## ADDENDUM NO. 1

### ARC East Well Pump Station Improvements

LRCCD BID NO. 17008

## **ARC East Well Pump Station Improvements Bid 17008**

IMPROVEMENT PLANS FOR  
**ARC EAST WELL PUMP STATION IMPROVEMENTS**  
 YARD PIPING

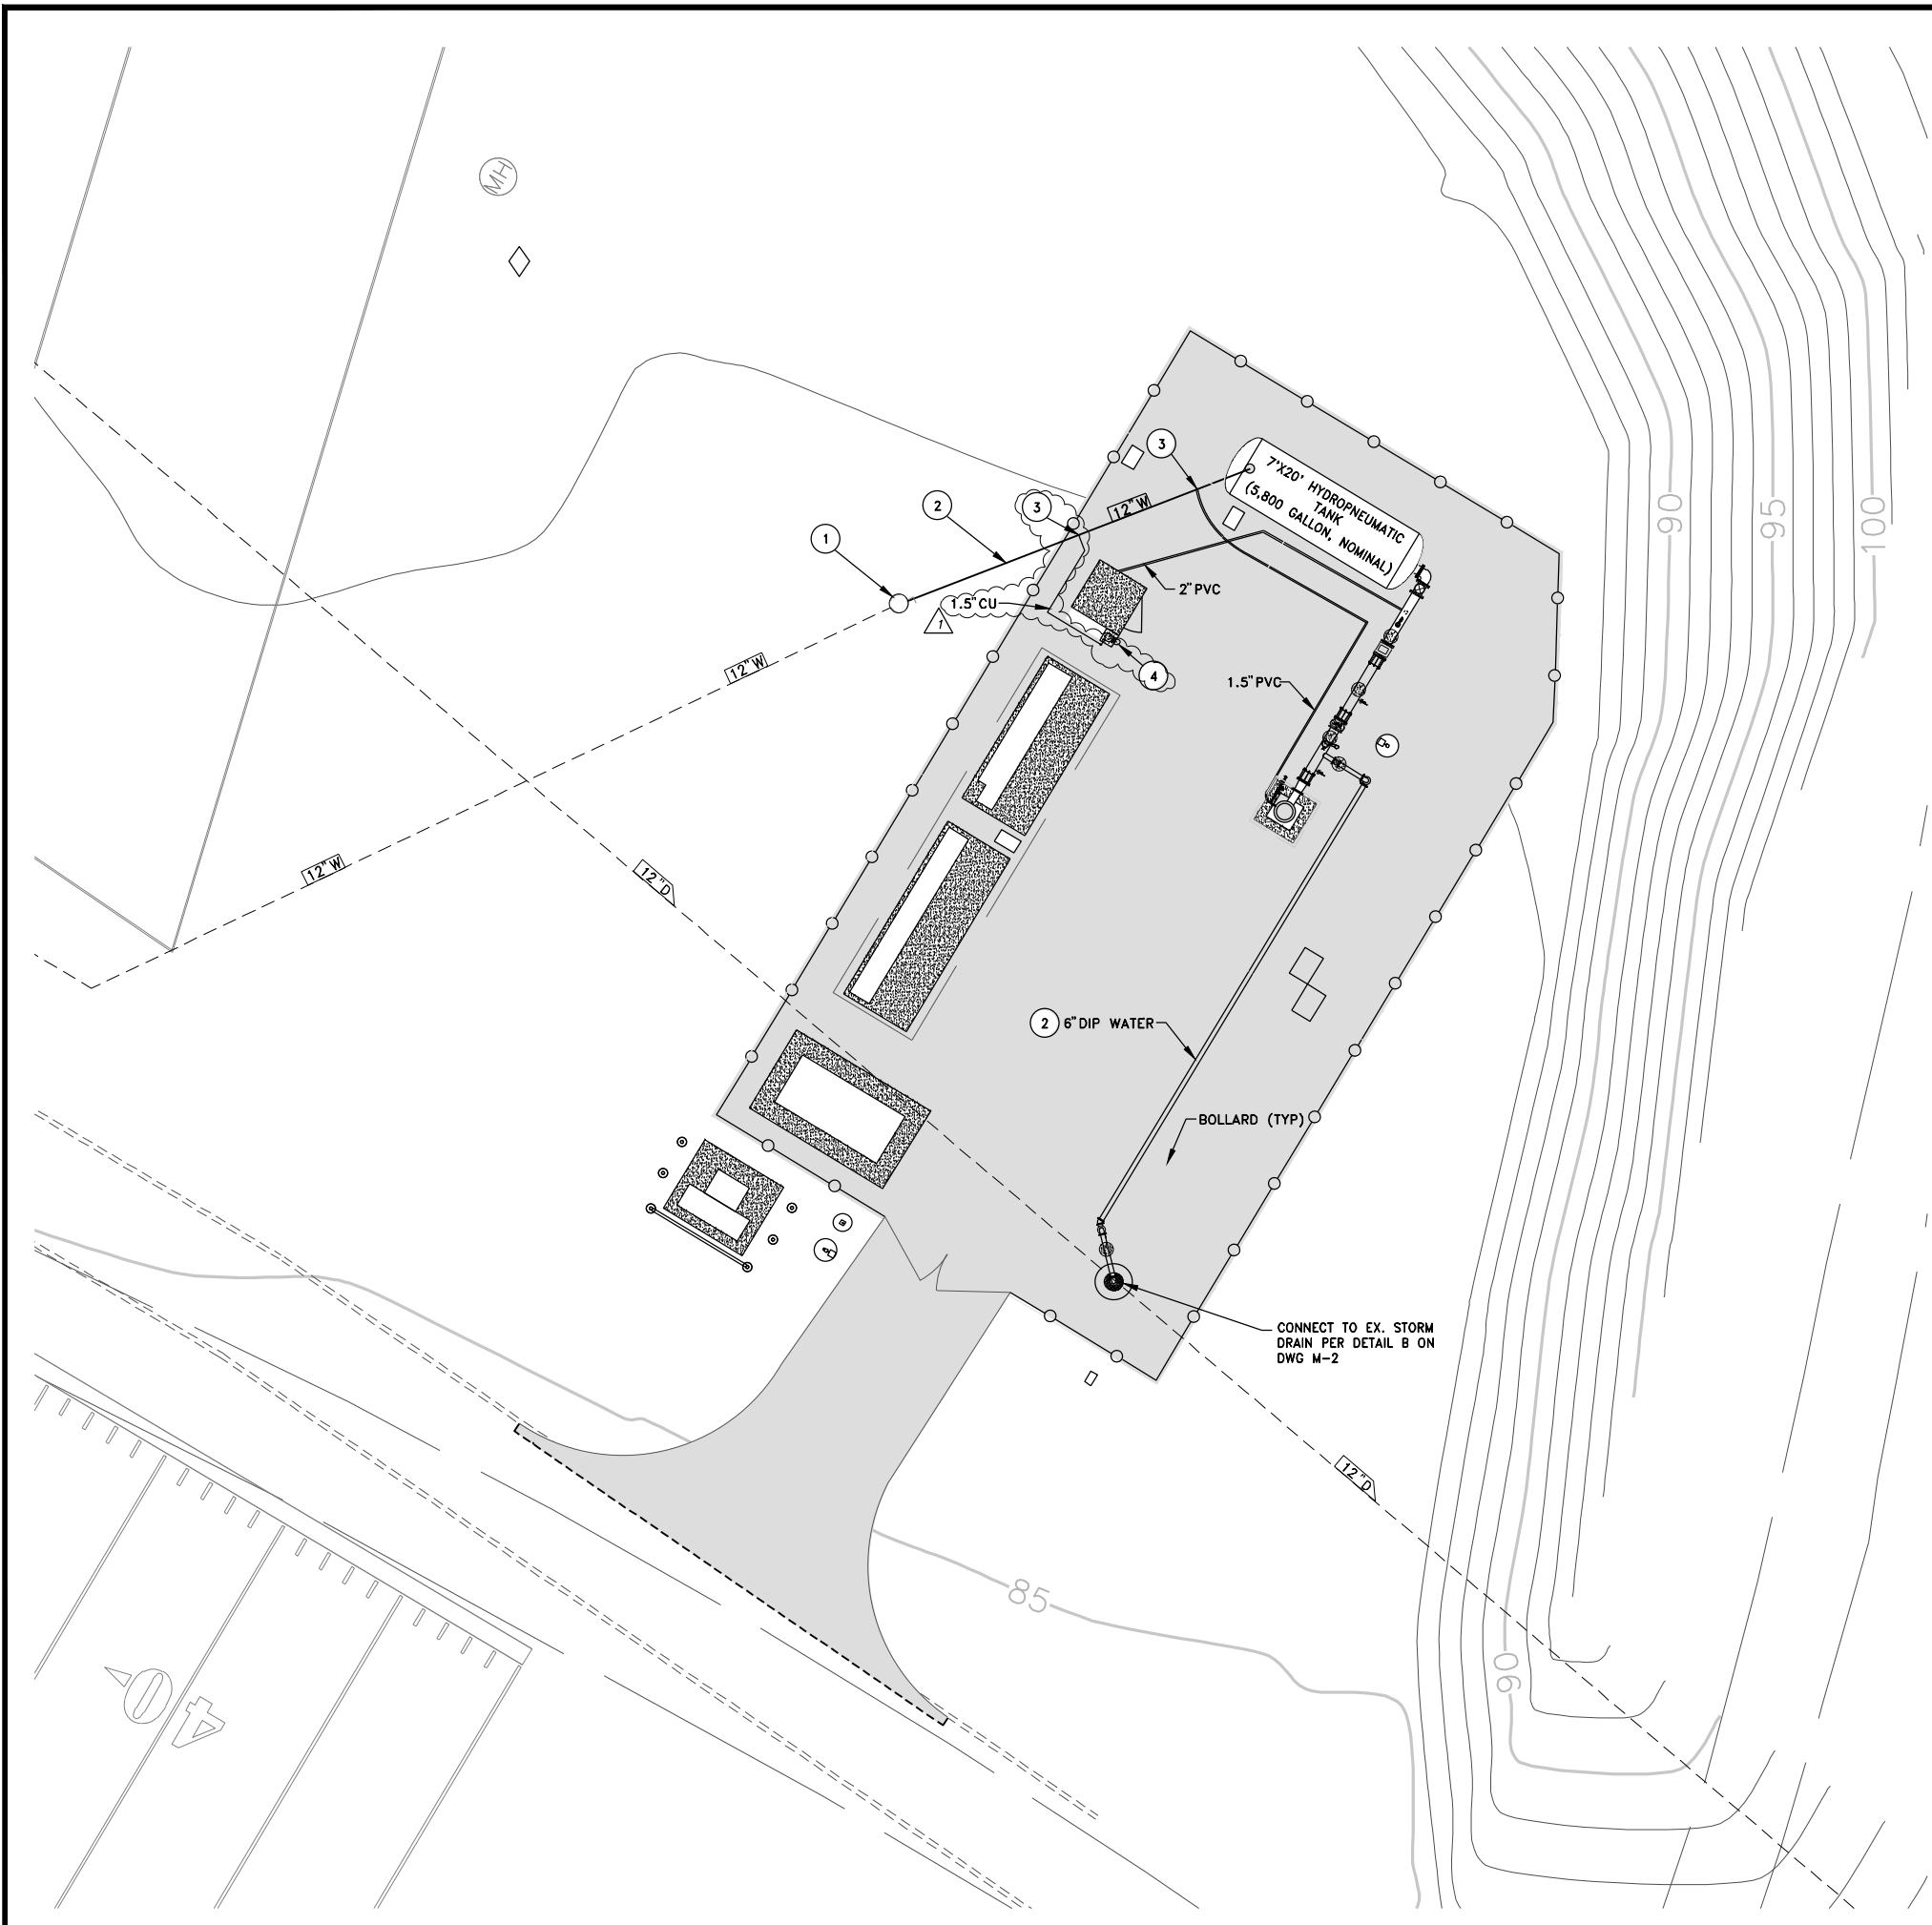
10. Q. On sheet P-2, the Pre-Lube is shown coming off the 12" Well Discharge piping and on Sheet C-3, it is shown coming off the 12" pipe after the Hydropneumatic tank. Please clarify the location the Pre-Lube is to come from.

18. Q. P-2 shows a backflow preventer, safety shower and eyewash station and a hose bibb. Please provide locations and specifications.

4 PROVIDE 18"-SQUARE x 8" THICK CONCRETE PAD WITH #5 @ 12" FOR COMBINATION SHOWER/EYEWASH BASE MOUNTING. PROVIDE AND INSTALL NON-FREEZE TYPE COMBINATION EMERGENCY SHOWER AND EYEWASH UNIT ON PAD WITH STAINLESS STEEL ADHESIVE ANCHORS AND HARDWARE PER MANUFACTURER'S RECOMMENDATIONS. COMBINATION SHOWER/EYEWASH SHALL BE ANSI Z358.1 COMPLIANT SUITABLE FOR OUTDOOR INSTALLATION WITH THERMOSTATICALLY CONTROLLED ELECTRIC HEAT TRACED CABLE. UNIT SHALL ALSO INCLUDE REMOVABLE 3/4" FOAM INSULATION AND AN ABS PLASTIC GREEN JACKET WITH ELASTOMERIC SEALS FOR ALL SEAMS AND OPENINGS IN THE JACKET THAT PREVENTS FREEZING DOWN TO AMBIENT TEMPERATURES OF 15°F. UNIT SHALL BE HAWS CORPORATION MODEL 8317CTFP, GUARDIAN EQUIPMENT CO. MODEL GFR3110, OR EQUAL. PROVIDE 1-1/2" BRONZE GATE VALVE ON COPPER SUPPLY PIPE 6" ABOVE GROUND, AND ROUTE SUPPLY TO UNIT. INSULATE ALL EXPOSED PIPING.

| EAG                 |  | ADD SHOWER/EYEWASH - ADD#1 |  |

Answer: Pre-lube routing source shall be as shown on Drawing C-3.

Answer: See Drawing C-3, Revision 1, included in the Addendum for emergency eyewash/shower information. There is no backflow preventer or hose bibb.

2. **REPLACE** “Drawing C-3 Yard Piping”, with “Drawing C-3 Yard Piping, Revision 1” (Attached)
3. Drawing M-1: **REVISE** Detail 2 per below:
- a. **ADD** the following text below the callout text for the solenoid valve:  
“ASCO REDHAT 8210 SERIES, OR EQ”
  - b. **ADD** the following text below the callout text for the flow switch:  
“BRASS, SPDT, DWYER SERIES V6 FLOWTECT, OR EQ”
4. Drawing P-2: **DELETE** the “3/8” TUBING / 2”C W RAW WATER SAMPLE” tubing and carrier piping shown routed from the Pressure Instrument (PI) closest to the Well, and **REVISE** to install per Detail 2/Sheet M-2.
